Addendum #2 to Construction Documents
FY11 Security Enhancements for GRC Lewis Field
Main Gate Area, Phase 3
Project #10231
August 29, 2011

Answers to Submitted Questions:

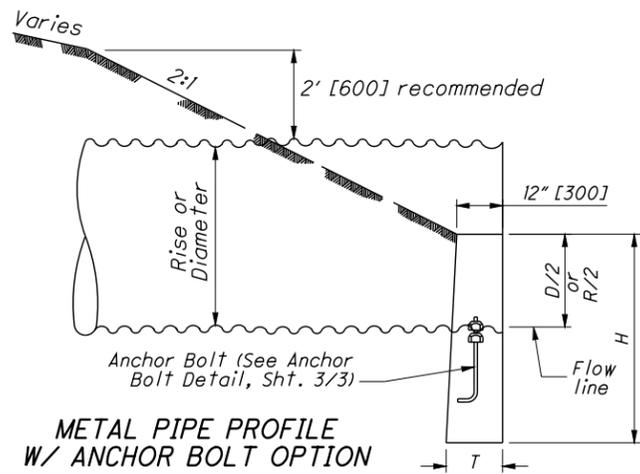
21. *Q: Please refer to contract drawing E-601 dated 7/8/11 concerning the Nema 12 Duplex/Alternating Pump Control Panel. Please advise the Horsepower ratings of Pump 1 and Pump 2. Please advise if integral overload relays are required. Please advise if an integral over current protective device (circuit breaker or fusible switch) is required. If so, please advise ampere rating.*

A: Typical for pumps P-1A, 1&2, P-1B, 1&2 and P-2, 1&2. – See drawing M-701 for horsepower ratings.

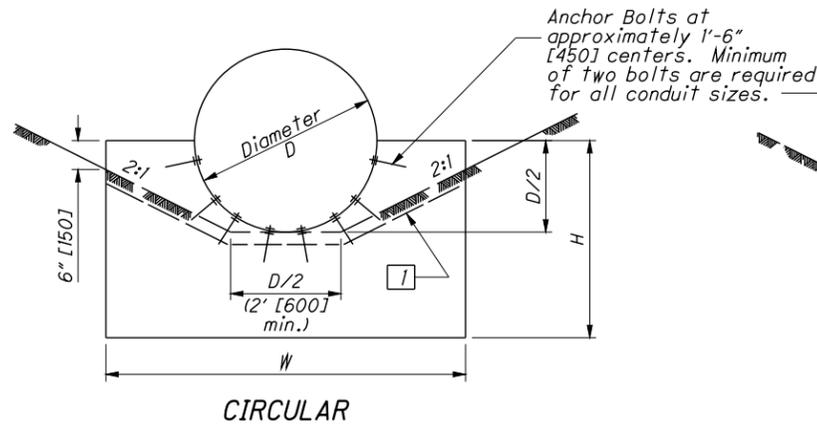
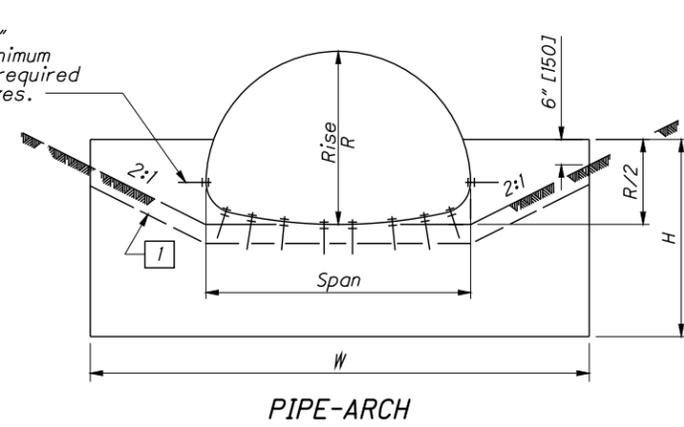
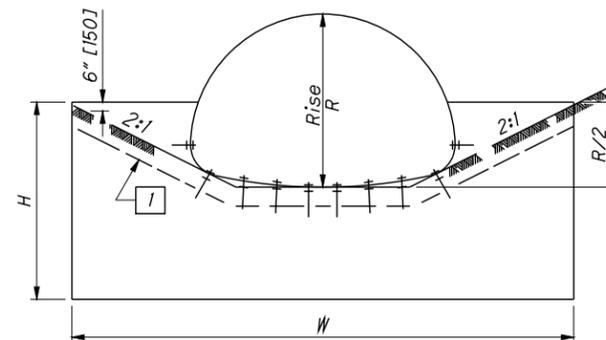
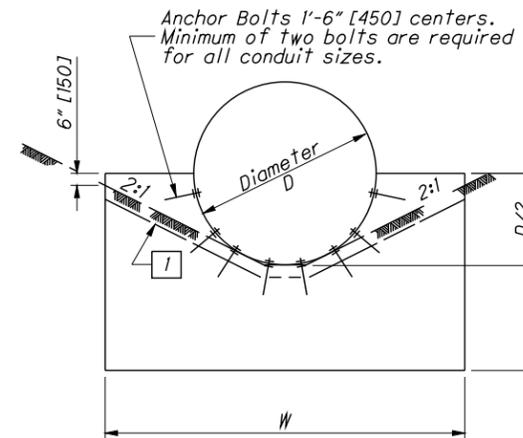
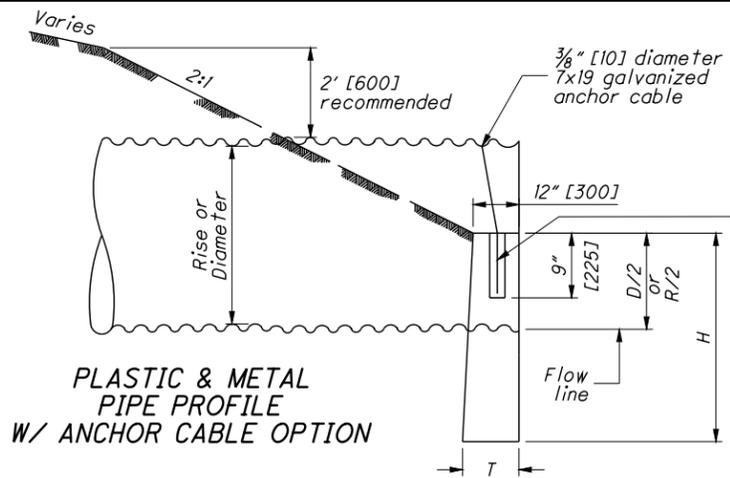
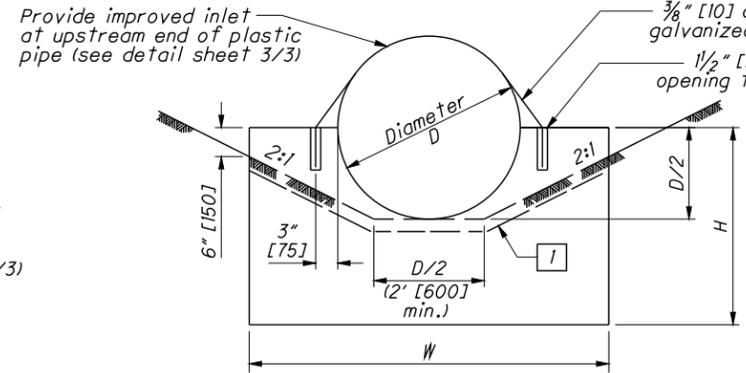
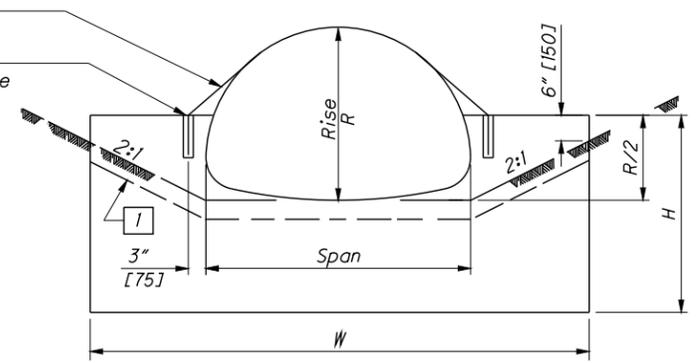
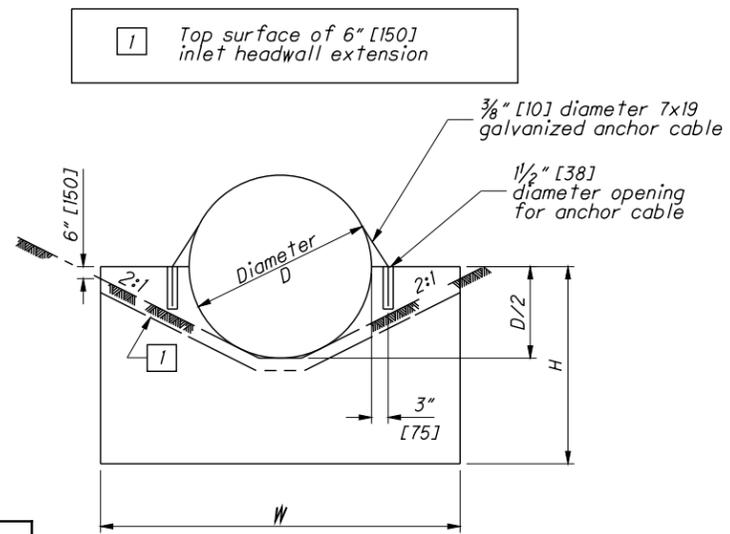
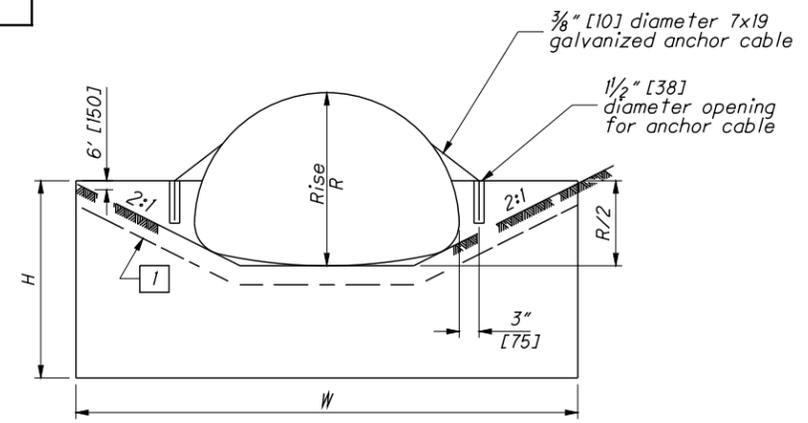
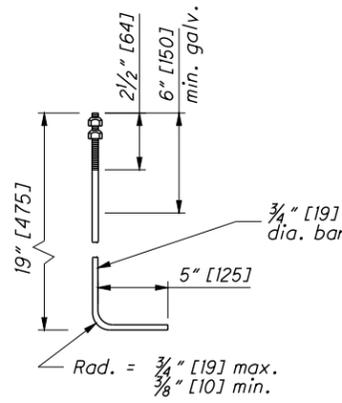
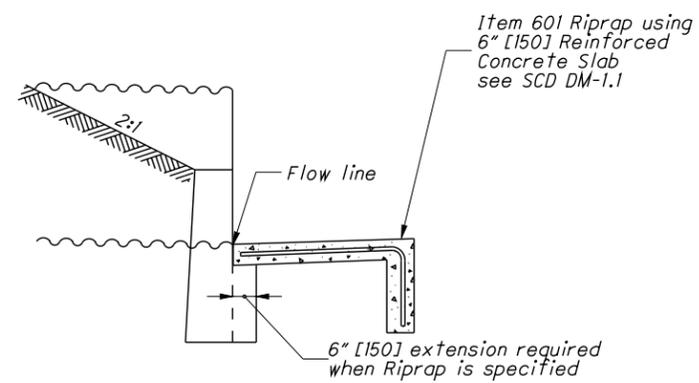
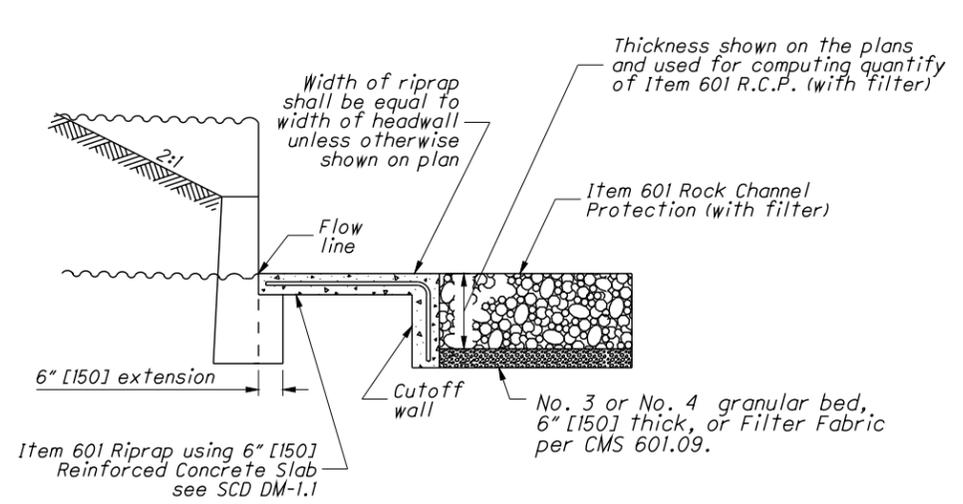
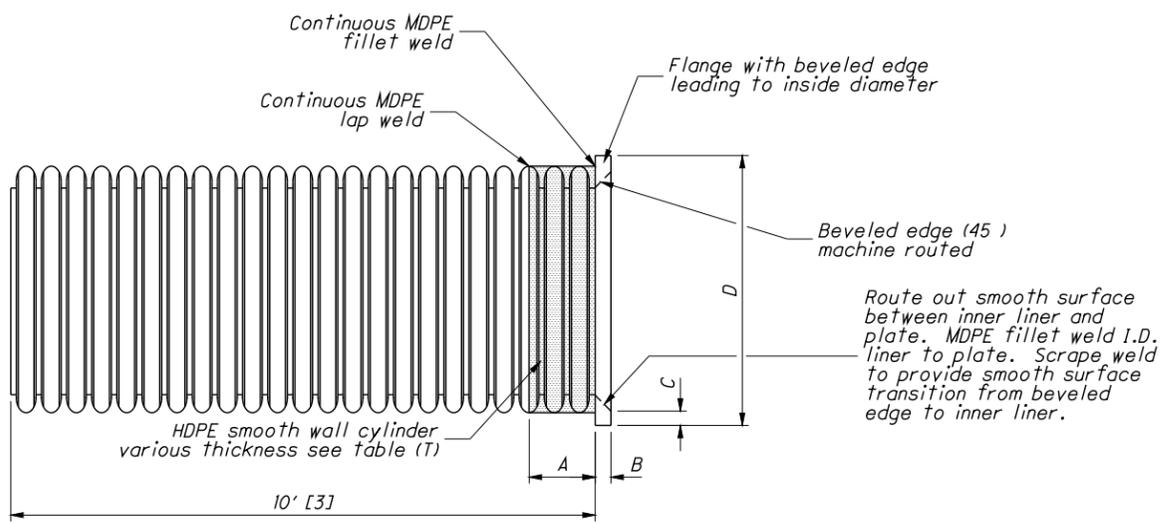
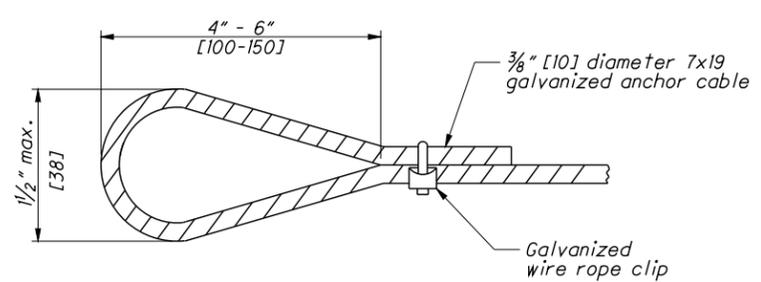
6. *Q: Is the 500 MM headwall on C 105 a half height of full height headwall? The detail given is for a full height headwall but does not show the requirements for the 500 MM.*

A: Change the pipe size from 500 mm (20 in) to 600 mm (24 in) for all instances 500 mm pipe is referenced on C105. Use half height head wall as specified on ODOT STD drawing HW 2.1 (attached). Contractor shall make all the necessary changes to all referenced details to allow for the use of the 600 mm pipe size instead of the 500 mm. Contractor shall also install a new headwall for outfall 16 to allow for the detention basin.

1 GRADING PLAN

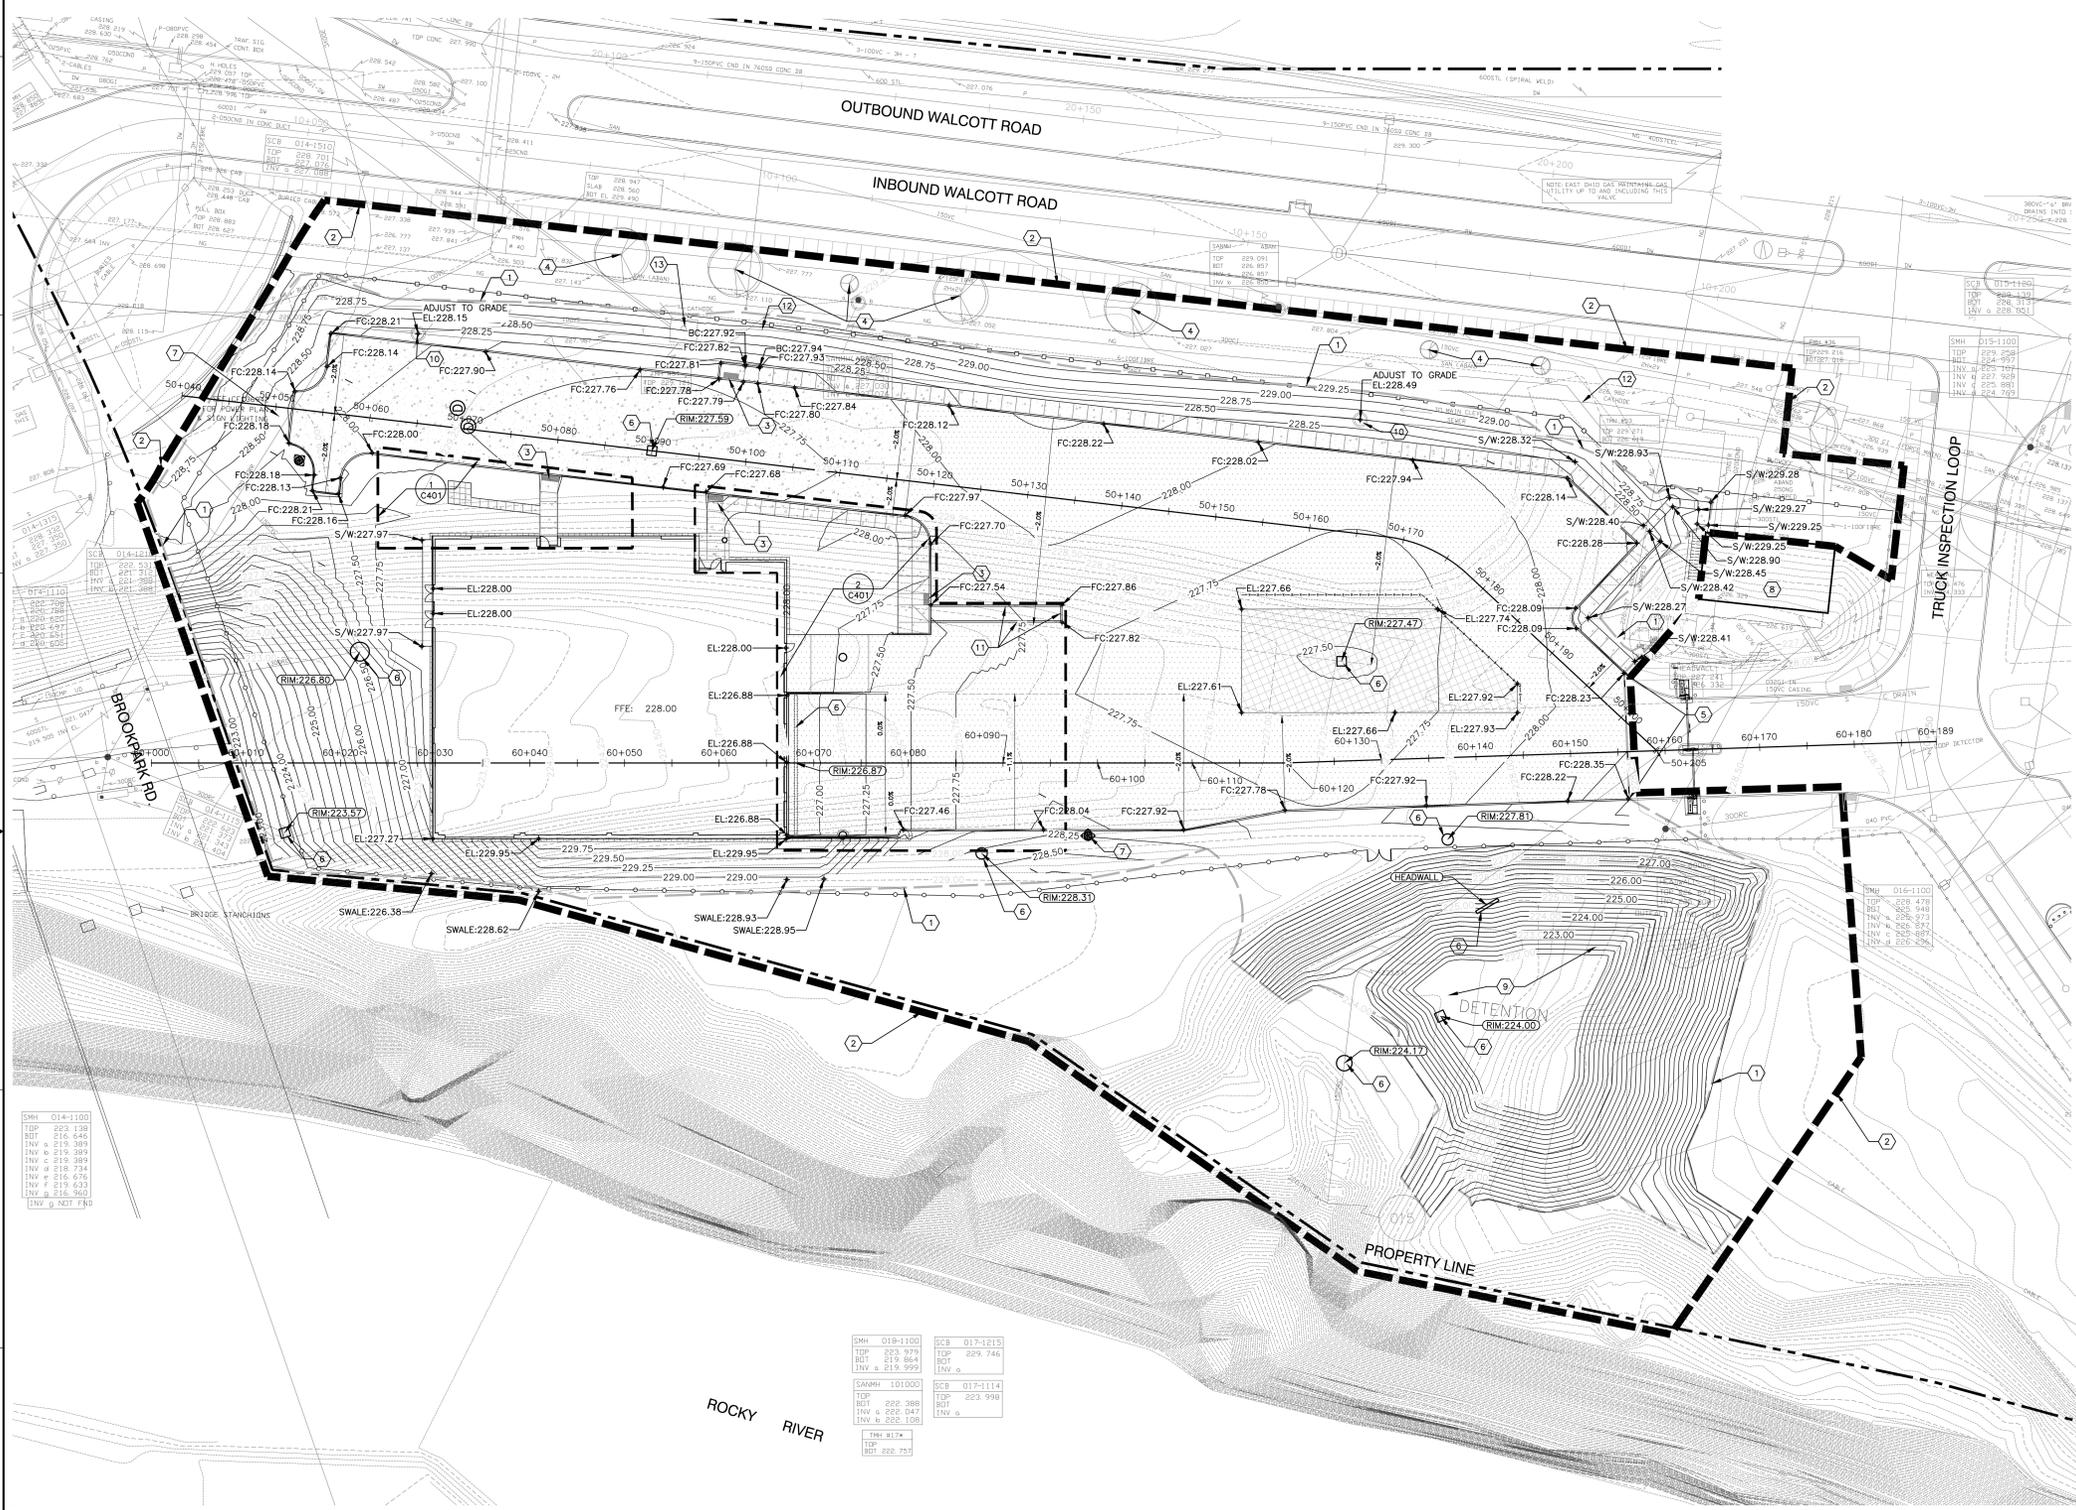
23. It has been found that the existing grading is difficult to read on the civil drawing C-102 that was included in the bid package. Please see the attached re-printed version of C-102 where the existing grading is darker and more legible. Please also find the AutoCAD version of C-102 for use in performing earthwork calculations.
